Engineering II 3229 Lab Remodel, Bldg. 503  
FM140301S/987834  
**Addendum No. 1**

ADDENDUM NO. 1

# PARTIAL PLAN

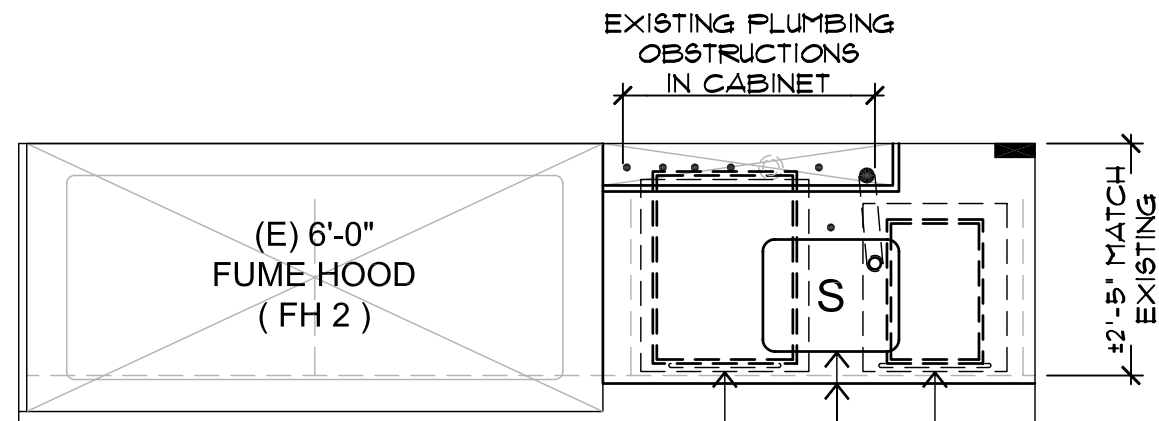
- III. DRAWINGS**
- Item No. 3-1. **MODIFY Sheet A2.2, Proposed Floor Plan, at cabinet west of Fume Hood 2, "WOOD BASE CAB'S TO REMAIN."** as follows:
- "See attached 'Partial Plan' Drawing. Cabinet to be replaced with material and finish to match existing with two (2) rolling carboy dollies with Nalgene bins."

21"x24"x5" HIGH MAX. EPOXY POWDER COATED STEEL ROLLING CARBOY DOLLY w/ + 20" STAINLESS STEEL LOOP HANDLE w/ 32 GAL. NALGENE BIN, THERMO SCIENTIFIC #14100-0045 OR EQUAL. VERIFY HEIGHT OF CARBOY w/ BOTTOM OF SINK PRIOR TO FABRICATION.

18"x21"x5" HIGH MAX. EPOXY POWDER COATED STEEL ROLLING CARBOY DOLLY w/ + 20" STAINLESS STEEL LOOP HANDLE w/ 16 GAL. NALGENE BIN, THERMO SCIENTIFIC #14100-0040 OR EQUAL. VERIFY HEIGHT OF CARBOY w/ BOTTOM OF SINK PRIOR TO FABRICATION.
